V2500-A5/D5 PROPULSION SYSTEMS SERVICE BULLETIN

V2500-ENG-72-0426

# ENGINE - ACTUATING MECHANISM HP COMPRESSOR VARIABLE VANES - INTRODUCTION OF A REVISED CRANKSHAFT ASSEMBLY WITH REDUCED FRONT BEARING INTERFERENCE

Family Tree Fig.1

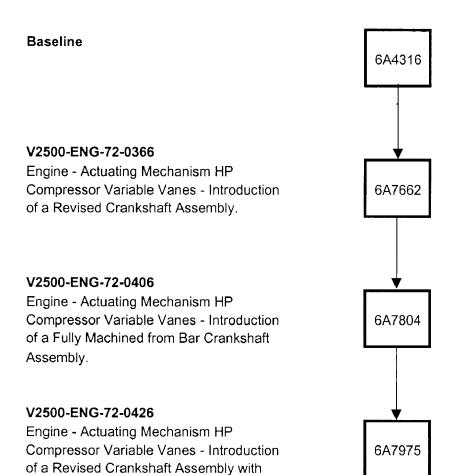
(1) This modification introduces a revised crankshaft assembly.

(a) The interference between the inner race of the front bearing and the front crankshaft journal has been reduced to between 0,0076 mm. and 0,0356 mm. on diameter by reducing the crankshaft journal diameter from 72,0446 mm. to 72,0306 mm. nominal.

The revised crankshaft assembly introduced by this Service Bulletin is freely and fully interchangeable with the existing item. Remove and Install in accordance with current overhaul procedures (Engine Manual, 72-41-00 Config-02, Disassembly and Assembly-02 (A5). Engine Manual, 72-41-00, Disassembly and Assembly-02 (D5). Aircraft Maintenance Manual, 75-32-42 Config-02, Removal/Installation (A5). Aircraft Maintenance Manual, 75-31-02, Removal/Installation (D5)).
